## **BAUGHN SUBDIVISION**

APPLICATION NUMBER 5 DATE February 1, 2018

REQUEST Subdivision

# DETAIL SITE PLAN

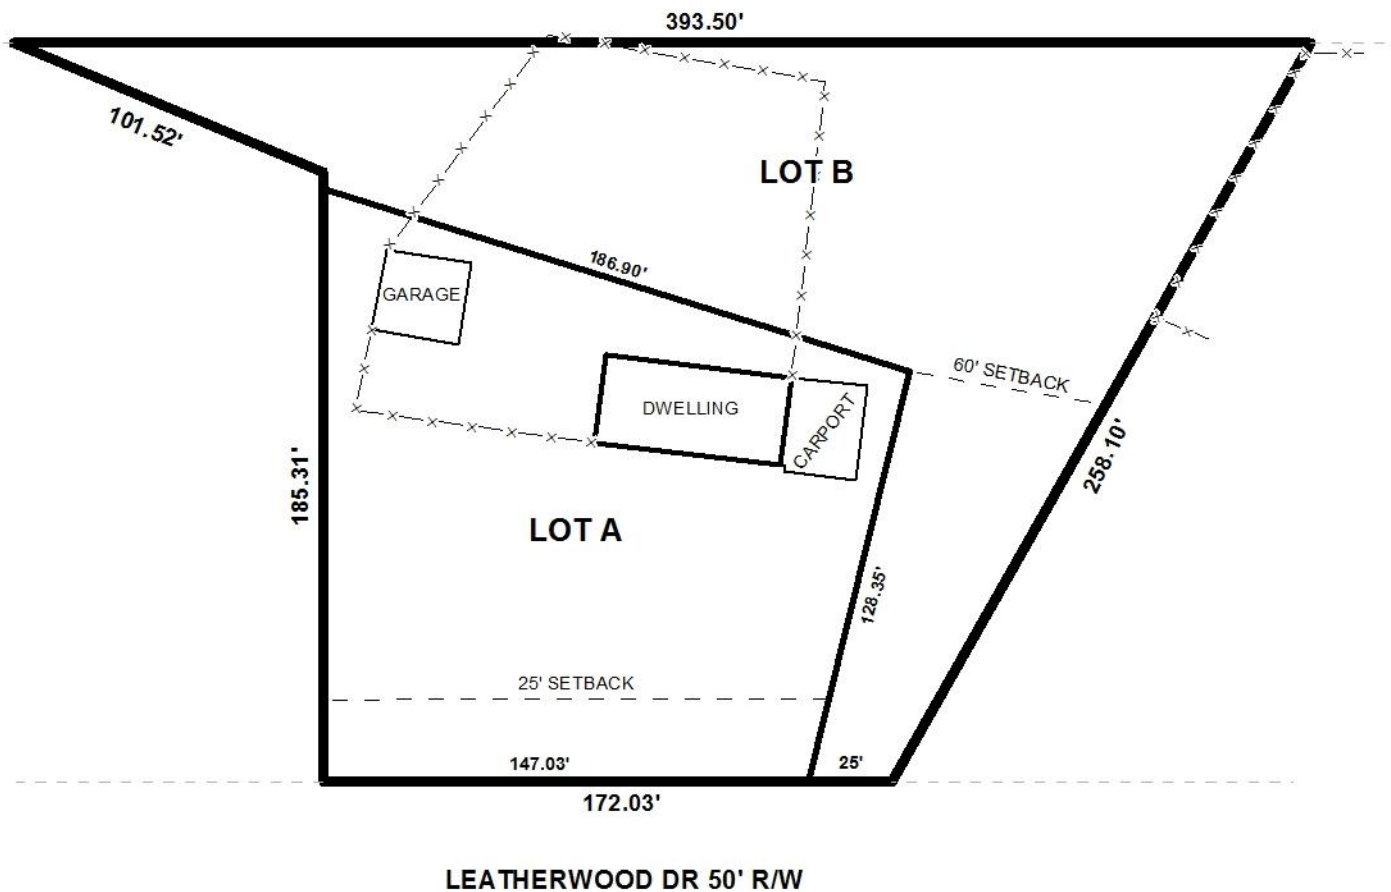
The proposed lots front Leatherwood Drive, an unpaved minor street without curb and gutter. As a minor street without curb and gutter, Leatherwood Drive requires a 60' right-of-way width. The preliminary plat illustrates a non-compliant 50' right-of-way width thus dedication is required.

It should be noted that the preliminary plat illustrates Lot B as a flag shaped lot. Section V.D.1. of the Subdivision Regulations state, "*Panhandle or flag lots shall generally not be allowed, but may be permitted only in those locations where varied and irregularly-shaped lot designs are common and the informality of design is consistent with other lots in the vicinity; or, where unusual circumstances such as an odd shaped lot exists; or, separate disparate uses exist on a single lot; or, where there are natural or pre-existing man-made barriers which may cause an undue hardship on the land owner or in the case of a family division*". The applicant did not provide documentation that this is a family subdivision, and has not indicated what other factors may necessitate the division as proposed. There do not appear to be any Planning Commission approved flag lots within the nearby area.

The preliminary plat illustrates a 25' minimum building setback line along Leatherwood Drive for the proposed Lot A. If approved, the 25' minimum building setback along Leatherwood Drive for the proposed Lot A should be retained on the Final Plat. The preliminary plat also illustrates a minimum building setback where the proposed Lot B is at least 60' wide. If approved, the building setback for the proposed Lot B should be retained on the Final Plat.

individual septic systems. The lot size information for each lot is depicted in both square feet and in acres on the preliminary plat and should be retained on the Final Plat, if approved.

As a means of access management, a note should be placed on the Final Plat, if approved, stating that each lot is limited to one curb to Leatherwood Drive, with the size, design and location of the curb cut to be approved by Mobile County Engineering and conform to AASHTO standards.
